The Commission has issued the enclosed Amendment No. 60 to Facility Operating License No. NPF-2 and Amendment No. 51 to NPF-8 for the Joseph M. Farley Nuclear Plant, Unit Nos. 1 and 2, respectively. The amendments consist of changes to the Technical Specifications in response to your application transmitted by letter dated September 19, 1985.

Amendment No. 60
License No. NPF-2

Amendment No. 51
License No. NPF-8

JOSEPH M. FARLEY NUCLEAR PLANT, UNIT NOS. 1 AND 2

Figure 6.2-1 Offsite Organization for Facility Management and Technical Support

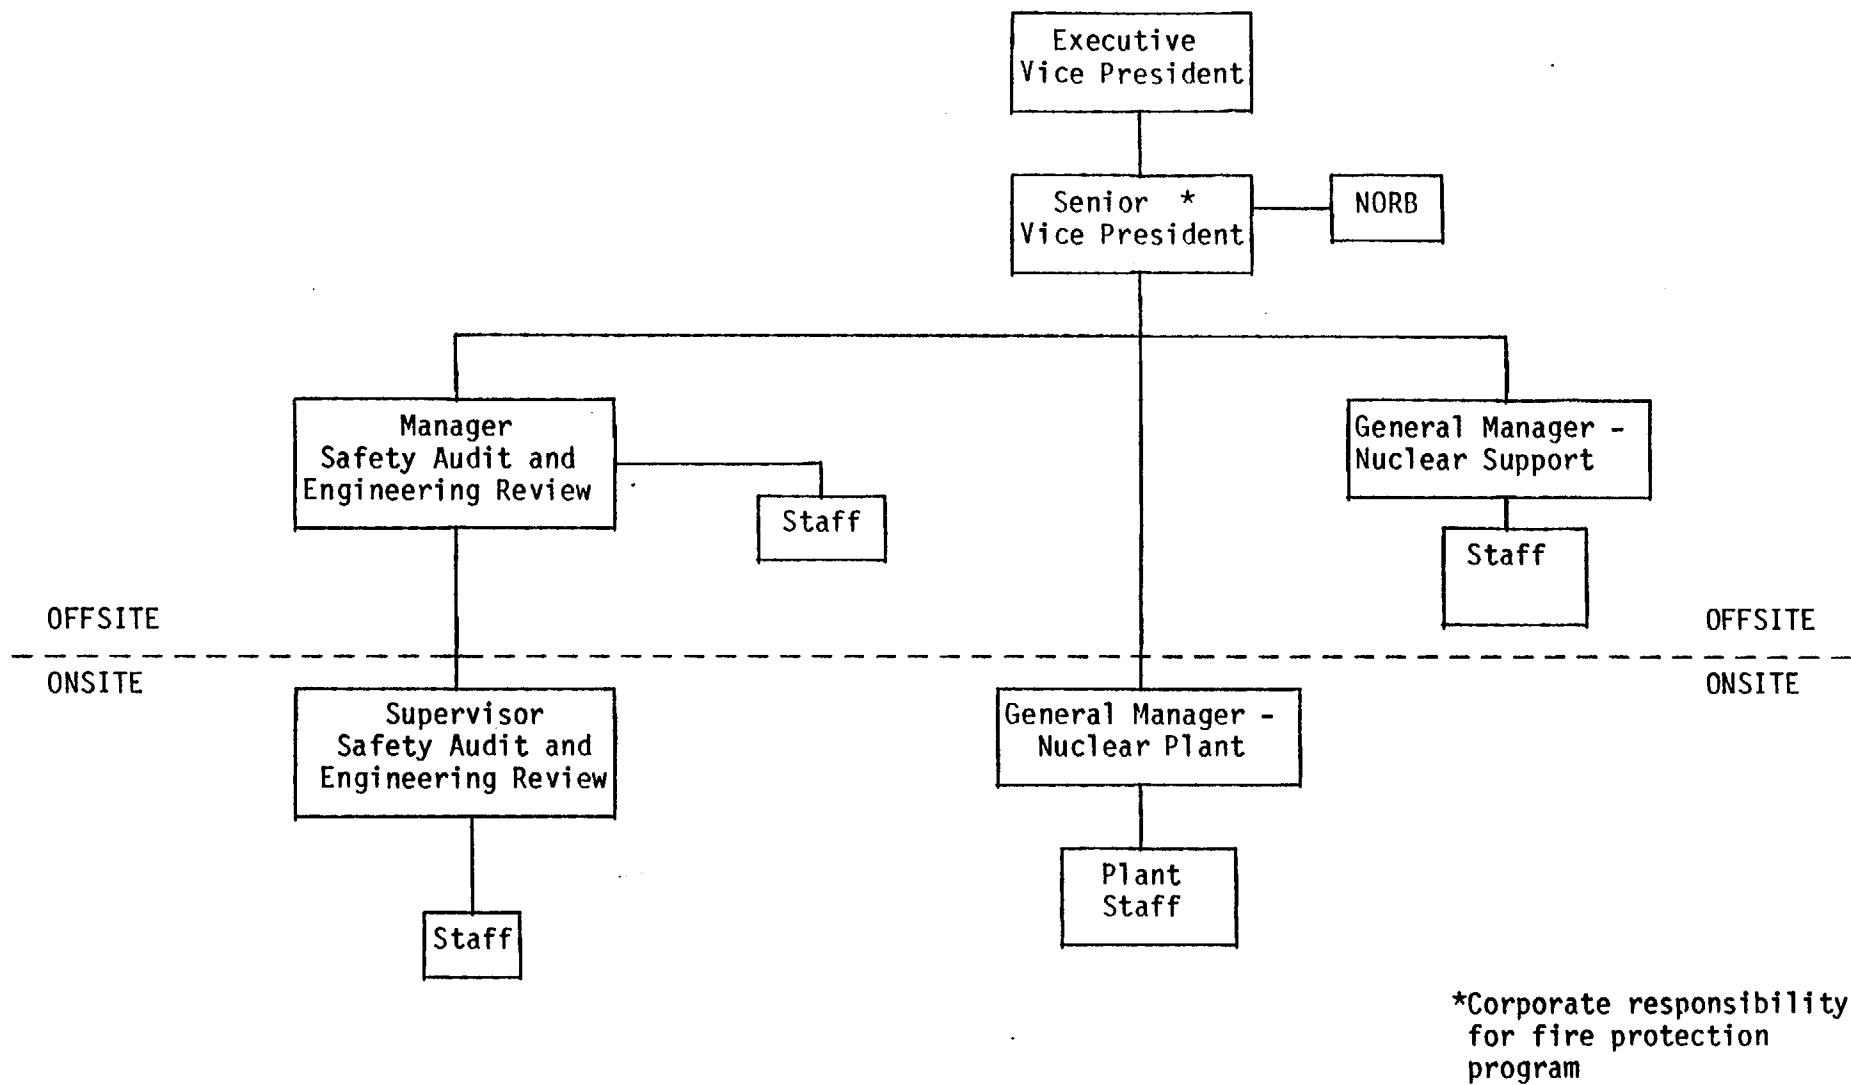
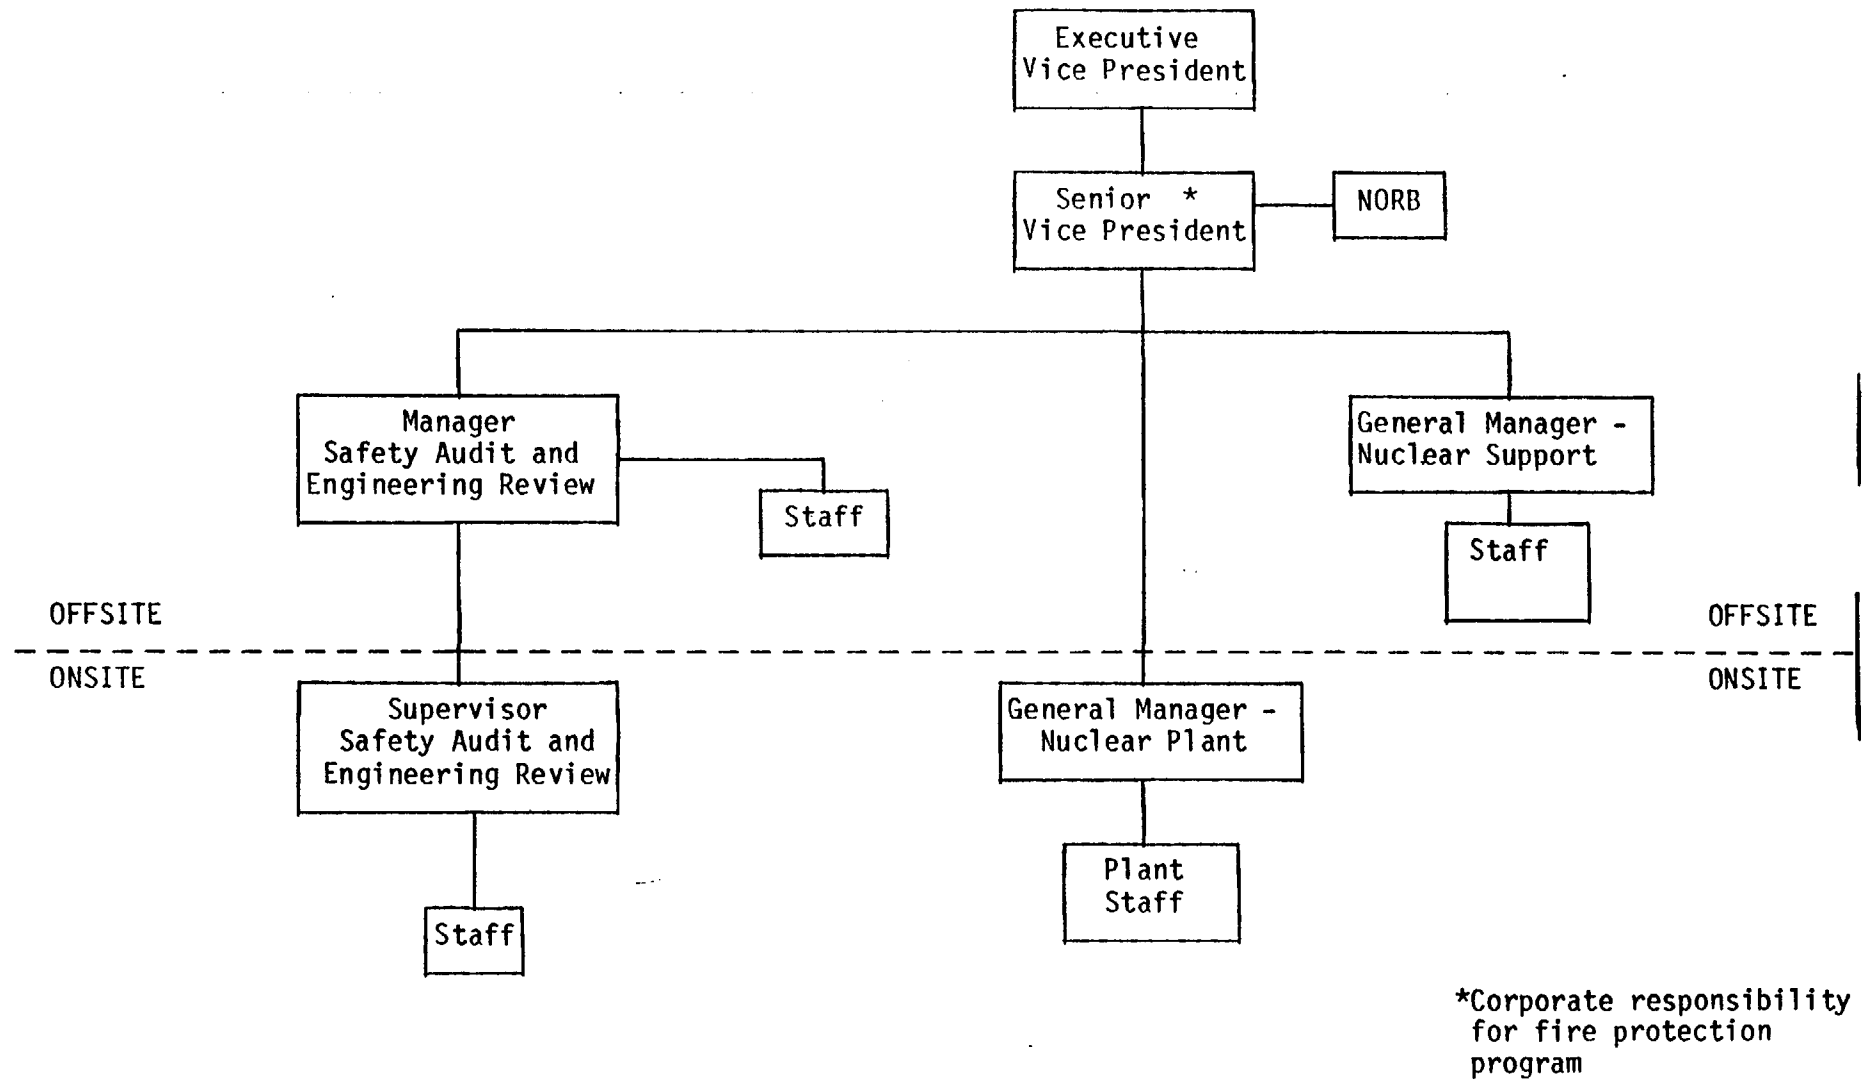
For the off-site organization, APCo proposed to combine and retitle the positions Manager - Nuclear Operations and Administration, and Manager - Nuclear Engineering and Technical Support (NETS) as General Manager-Nuclear Support. The functional responsibilities of the Manager-Nuclear Operations and Administration and the Manager-NETS have been delegated to the General Manager-Nuclear Support. The management change to a single General Manager-Nuclear Support also necessitates a change in the members of the Nuclear Operations Review Board (NORB). In order to preserve the current membership of four persons in the NORB, it is proposed that the General Manager-Nuclear Plant become a permanent member of the NORB.

Figure 6.2-2 Facility Organization

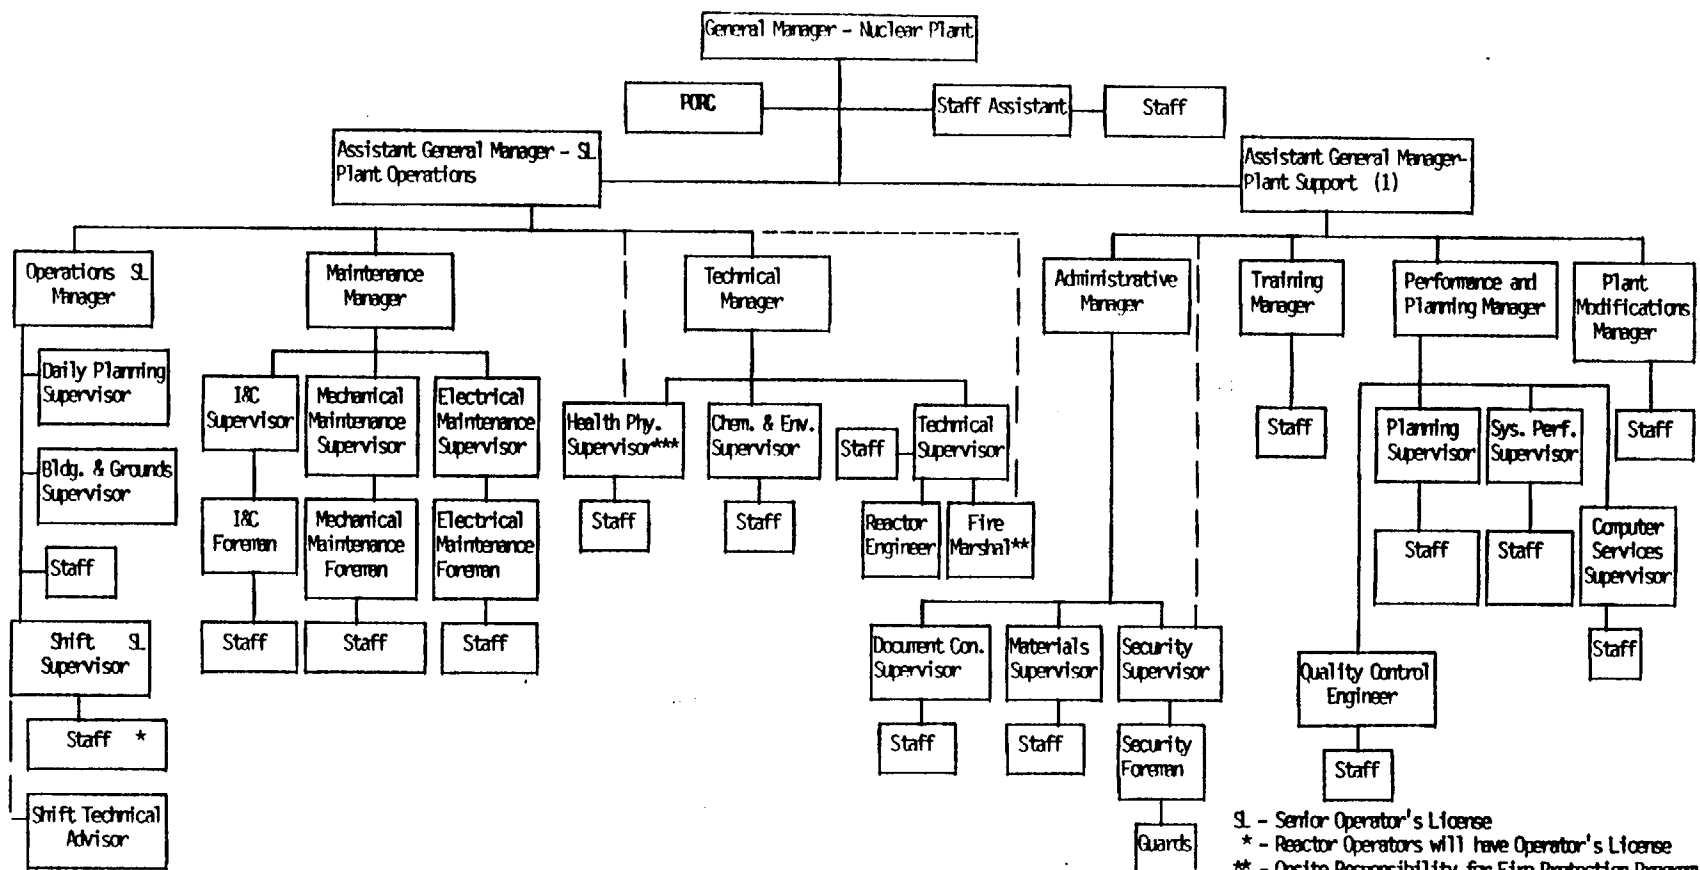
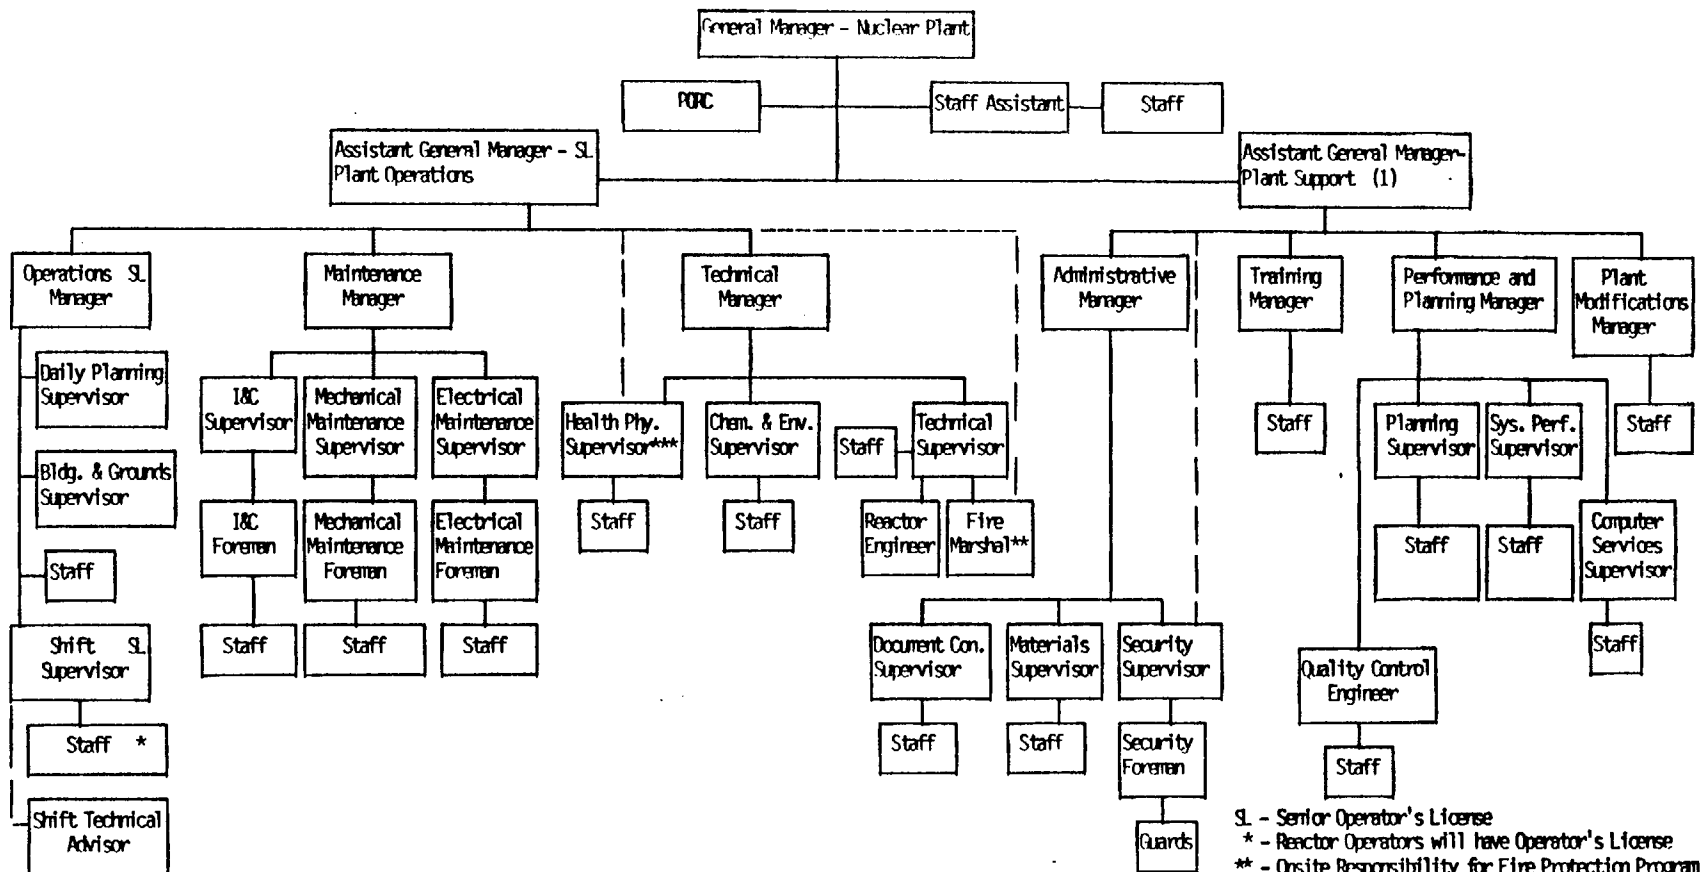
- (2) The Plant Modifications Supervisor is retitled Plant Modifications Manager and reports directly to the Assistant General Manager - Plant Support. Previously the position reported to the Systems and Performance Planning Superintendent. The change appears to enhance the position. The management of the plant modifications has become a very important post-licensing area of responsibility. Thus, the change could be a safety enhancement.

- (3) The change of the Computer Services Supervisor from reporting to the Technical Superintendent (Operations) to reporting to the Performance and Planning Manager (Plant Support) is more in line with actual computer usage at the facility. It also removes some administrative duties from the operations side of the organization.

- (4) The change to replace the Operations Supervisor function with an Operations Staff eliminates one level of management between the Operations Manager and the Shift Supervisor who are both directly responsible for day-to-day plant operations. Thus, the change places the Operations Manager in more direct control of plant operations and plant safety.

- (5) The changes to add a Daily Planning Supervisor and Building and Grounds Supervisor reporting directly to the Operations Manager raised some staff concerns. However, during a discussion between our staff and the APCo staff, APCo noted that the changes simply corrected an omission in

the earlier figure. These two groups have existed and reported in the same manner for years. Since the changes are considered as administrative corrections to Figure 6.2-2, we conclude that the changes are acceptable. However, we consider that the Buildings and Grounds Supervisor (who now reports to the Operations Manager) should more appropriately report in the plant support chain. This would reduce the administrative burden as we noted in (4) above. APCo should consider such a change to remove this maintenance function from the plant operations line of command in a future review of the organization.
